Preliminary Drainage Report

# Overlook at Homestead Subdivision El Paso County, Colorado

PCD Filing No.: **SP238**

Prepared: August 7, 2023

OVERLOOK FILING NO. 1  
 EL PASO COUNTY, COLORADO  
 PRELIMINARY DESIGN PLANS  
**EXCLUSION EXHIBIT DRAINAGE MAP**

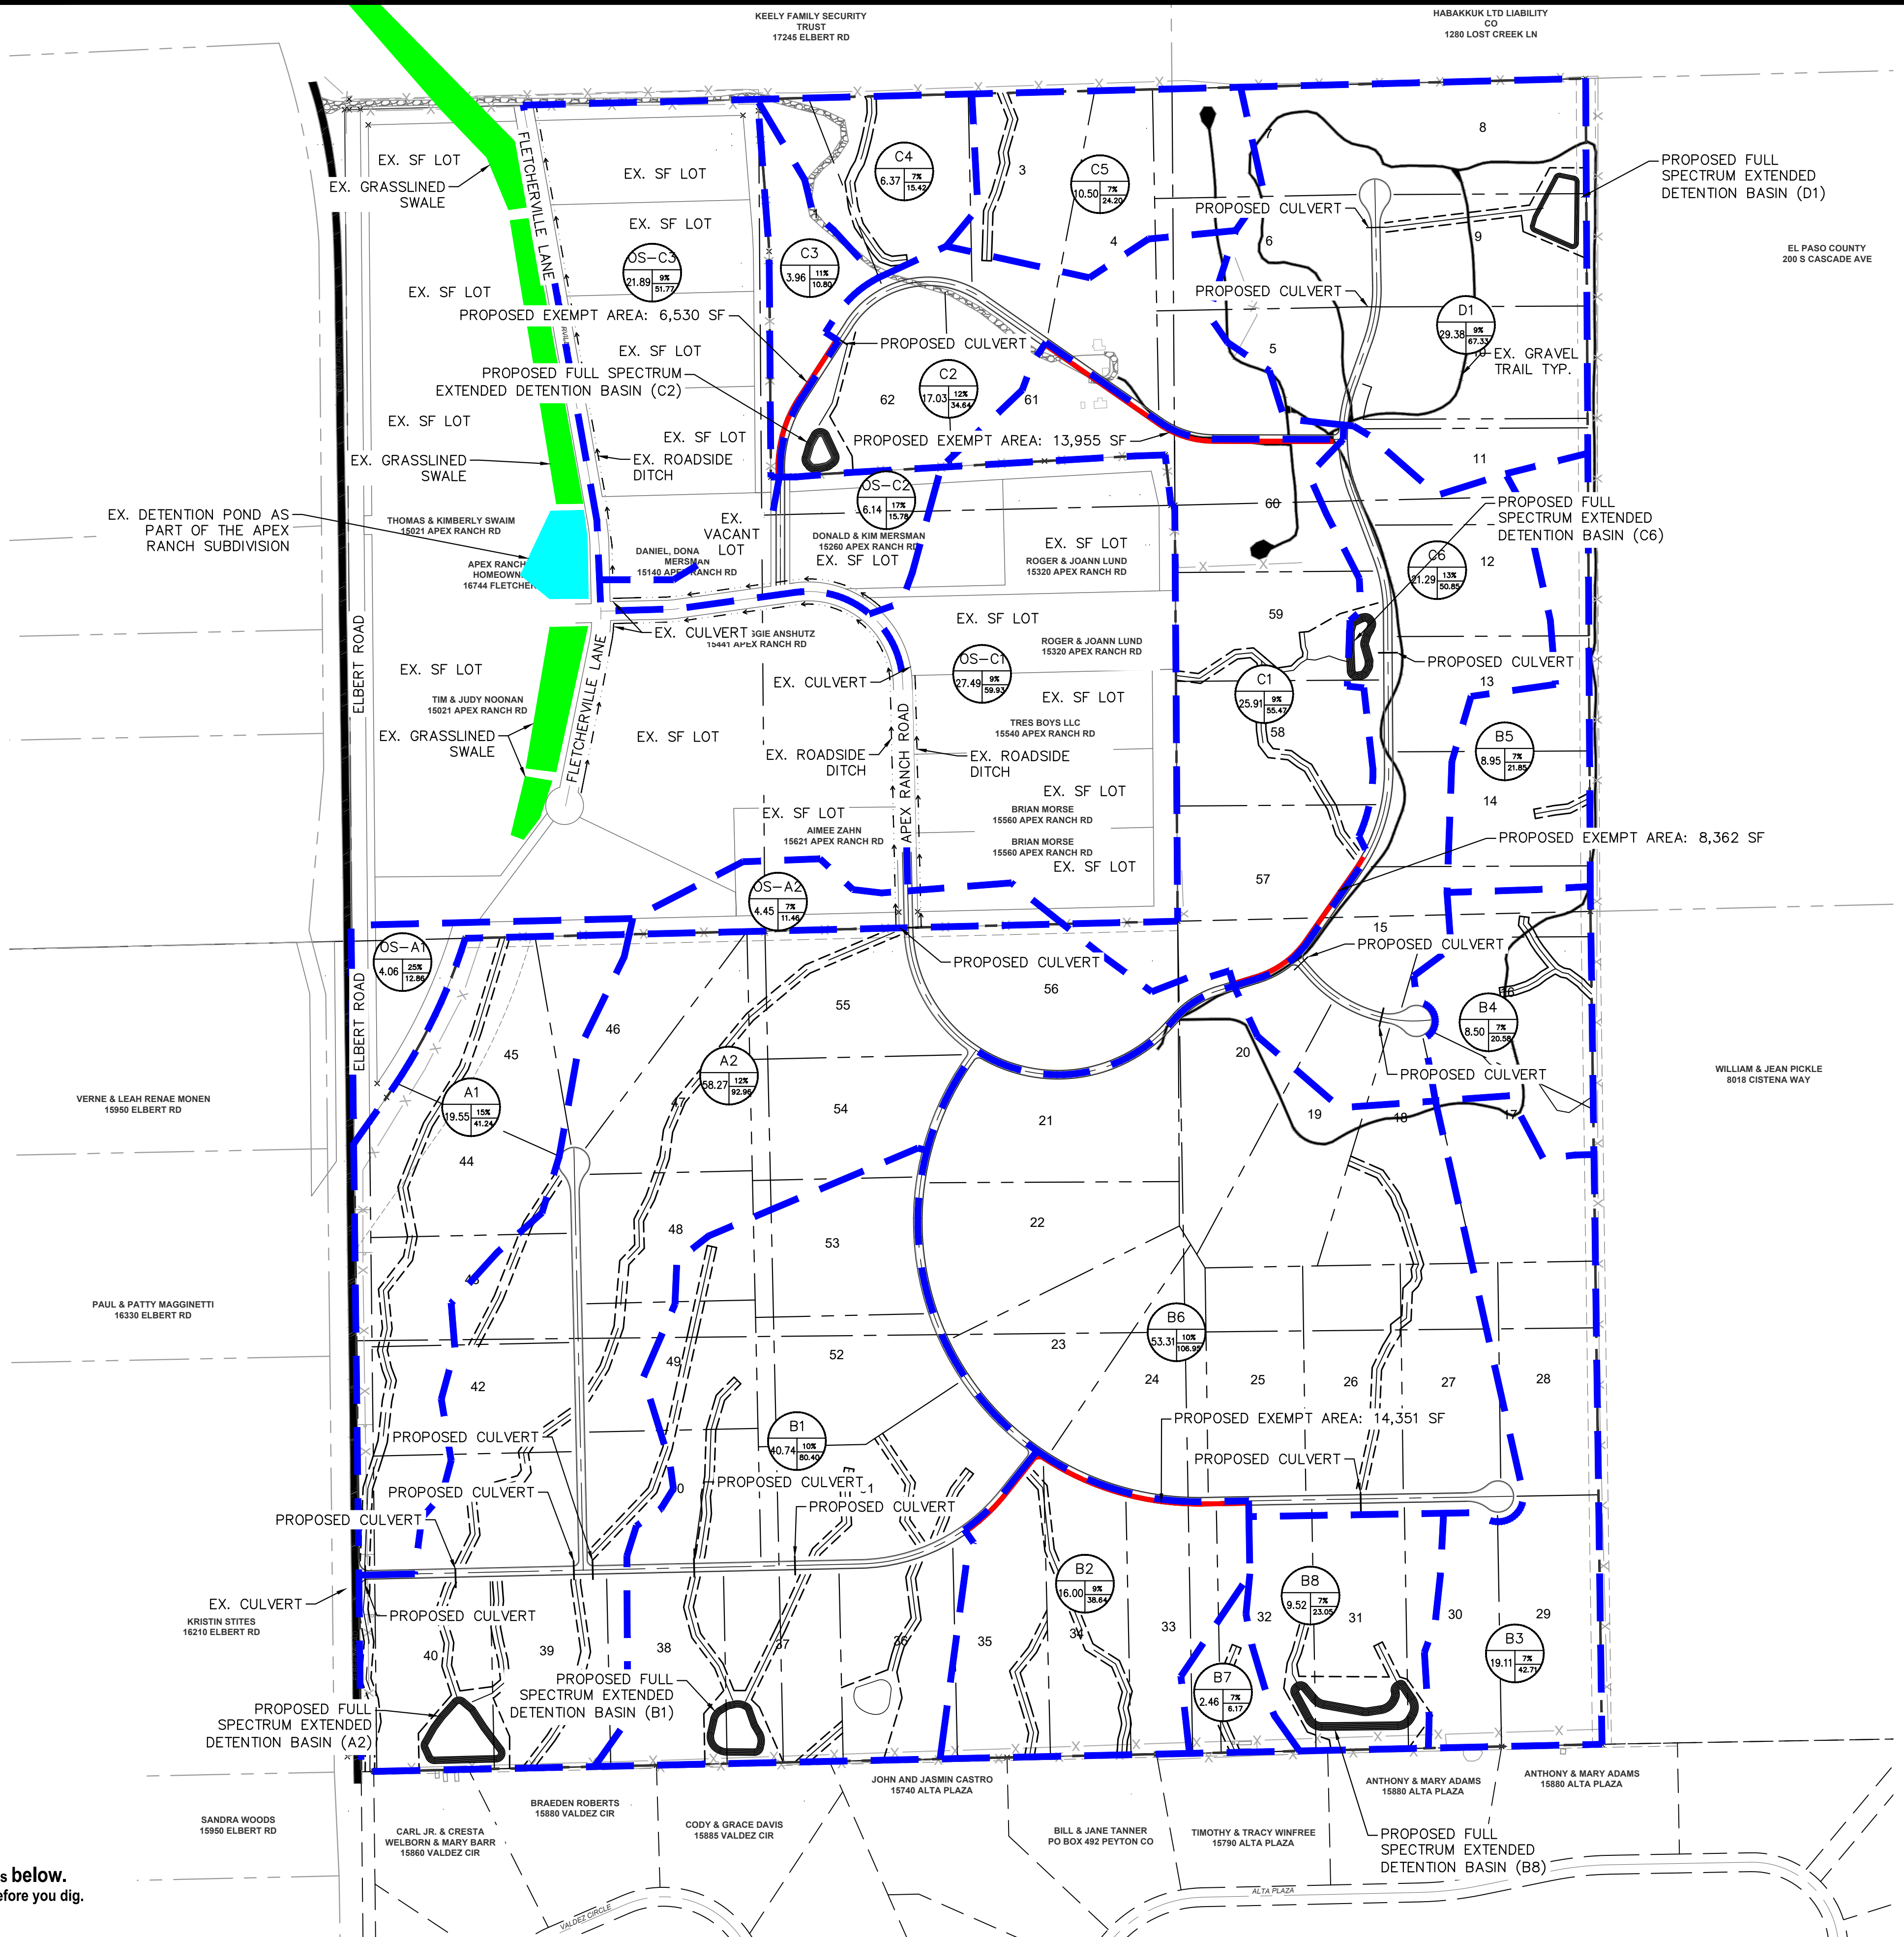
Please add the exclusion number for this (ECM App I.7.1.C.1)
